Effective Date: June 27, 2007	Revision No. 1 - Draft	Document No. SCA-SEC-TASK5-0056	Page No. Page 120 of 142
----------------------------------	---------------------------	------------------------------------	-----------------------------

Finding 4.5-3: Unmonitored Shallow and Deep Dose Resulting from Skin/Clothing Contamination

Finding 4.5-4: Inability to Properly Account for Neutron Doses

Figure 1. Front View of Array of Drums of UF₄ in Concrete Room

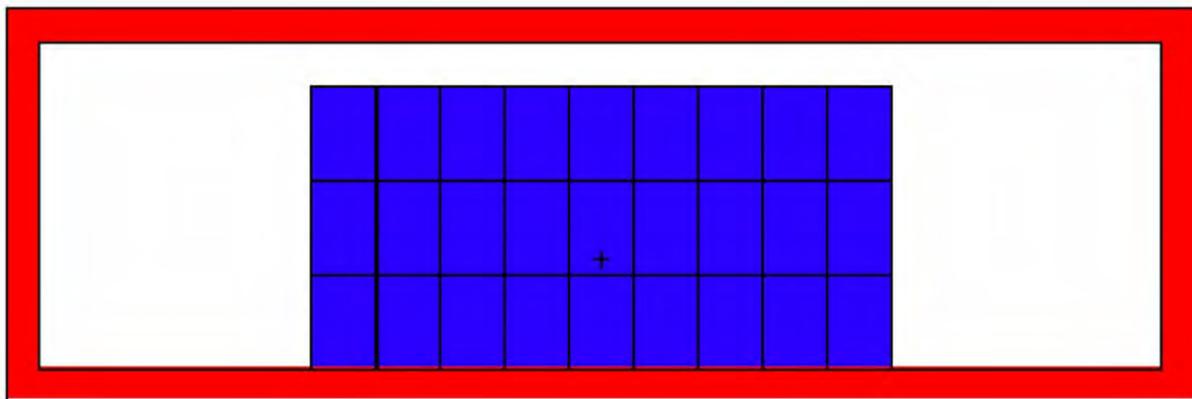
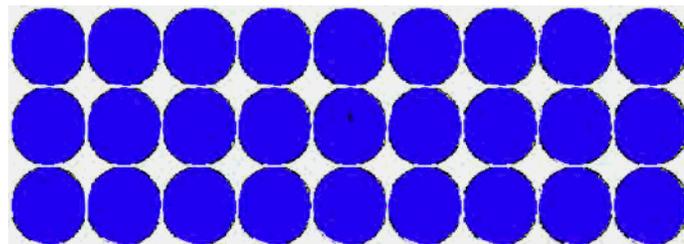
For example, SC&A performed a neutron-to-photon ratio calculation in behalf of a UF₄ source term that is defined by 81 drums that are stacked as follows: 9 drums in a line, 3 rows deep and 3 drums high (see Attachment 4.5-4.A). The η/γ ratio for this configuration yielded a **deterministic value of 0.4**, which is 4 times higher than the **geometric mean value of 0.10** cited in Table 6-10 of the FMPC TBD (ORAUT-TKBS-0017-6).

The results of the analysis are presented in Table 1. As shown in the table, the neutron:photon dose ratio varies from 0.13 for a single drum of natural uranium to 0.42 for an 81-drum array of 2% enriched uranium. Although Faust (2004) does not present neutron:photon dose ratios for natural uranium, we note that the geometric means of the distributions are 0.07 and 0.10 for depleted and low-enriched uranium, respectively. The lowest value in Table 1 thus exceeds this range, while the highest value is over four times higher than the value for enriched uranium presented by Faust. We therefore conclude that the neutron:photon dose ratios presented by Faust are neither scientifically correct nor claimant favorable.
